ADDENDUM NO. 2

Colonial School District

John G. Leach School

Bid Pack C – Re-Bid

C-601

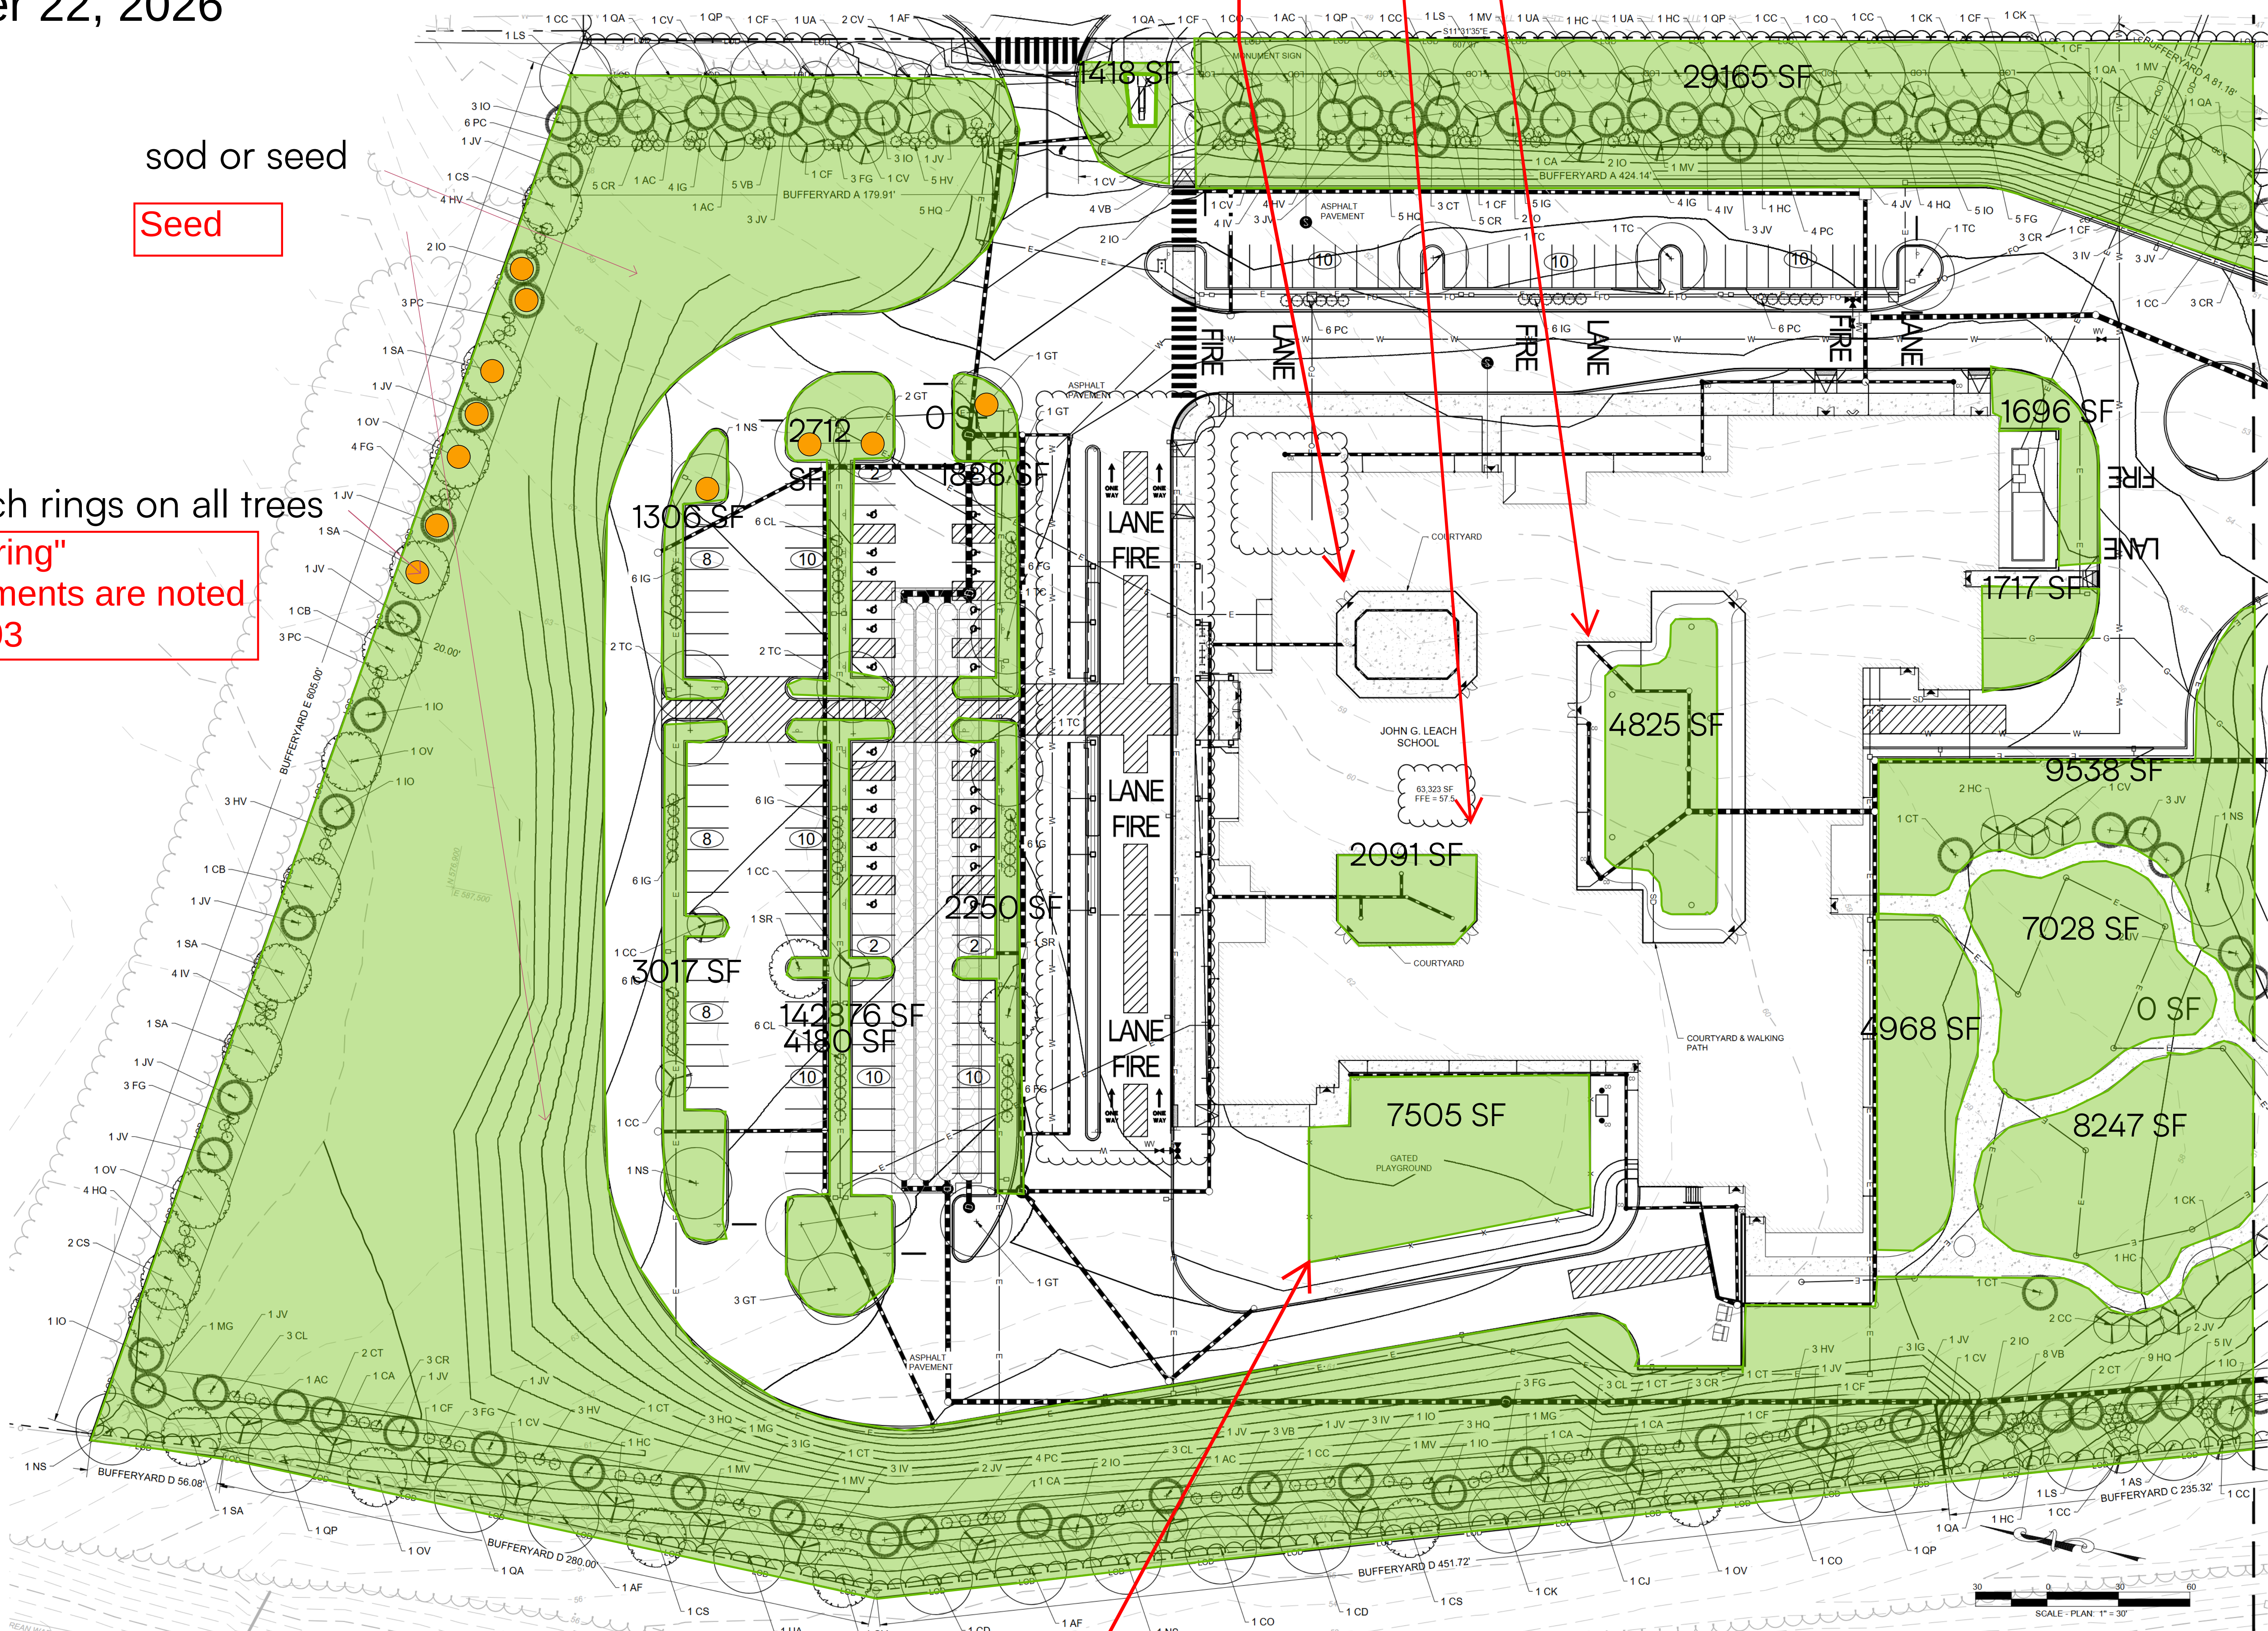
Mulch rings or mulch bed?

Is there irrigation?

Sod-Seed?

sod or seed

Don't think these are the right sizes. Should I size like the rest?

EDiS: "Mulch ring" requirements
are noted on C-603

No irrigation

Courtyard and Walking Path area
surfaces are noted on C-111

Seed

Mulch rings on all trees
"Mulch ring"
requirements are noted
on C-603

Sizes are as indicated on the planting schedule. All varieties listed as 5 gallon should be available in that size. This would be a younger tree 3-5 ft tall.
